RE: **Santa Fe Towing Office**
7901 Jacs Ln NE
Grading and Drainage Plan
Engineer's Stamp Date: 9/27/18
Hydrology File: D16D002A7

Based on the submittal received on 10/1/18, the Grading and Drainage Plan is approved for Building Permit and SO-19.

SANTA FE TOWING OFFICE
7901 JACS LN, NE
GRADING PLAN

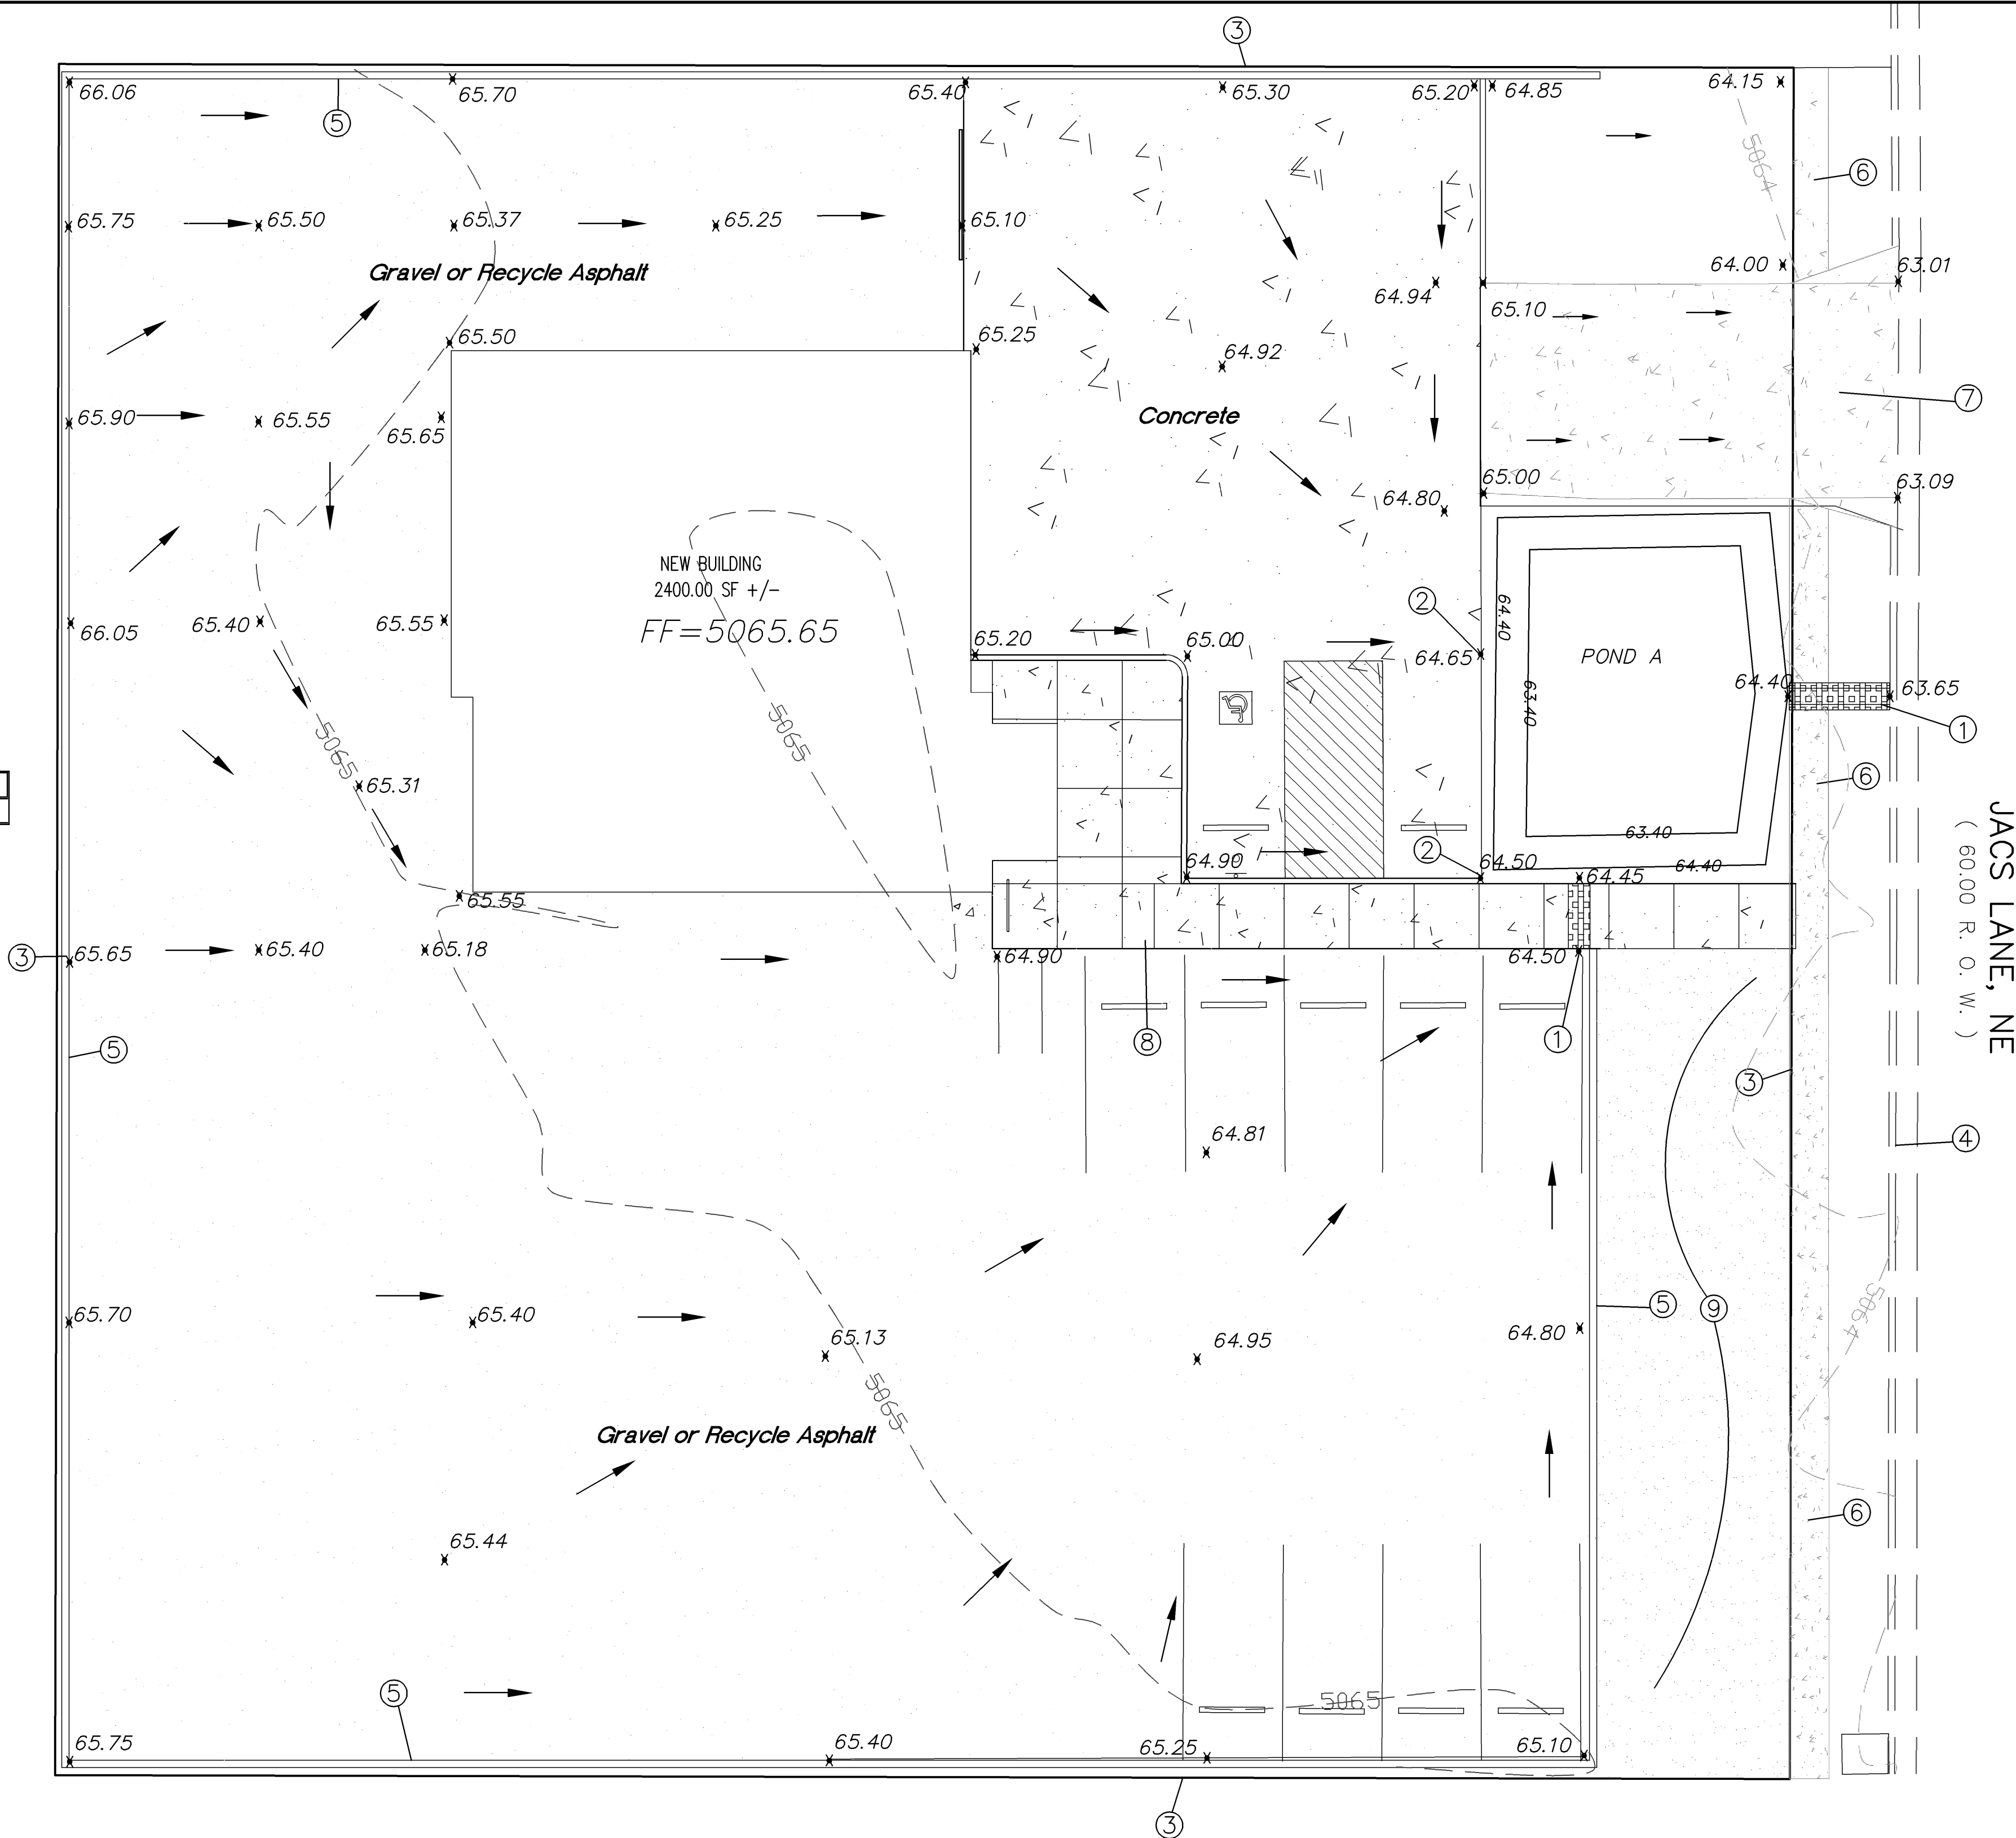
1. Engineer's Certification, per the DPM Chapter 22.7: *Engineer's Certification Checklist For Non-Subdivision* is required.
2. The sidewalk culverts must be inspected and approved by storm drain maintenance (Jason Rodriguez, jtrodriguez@cabq.gov or 857-8607).
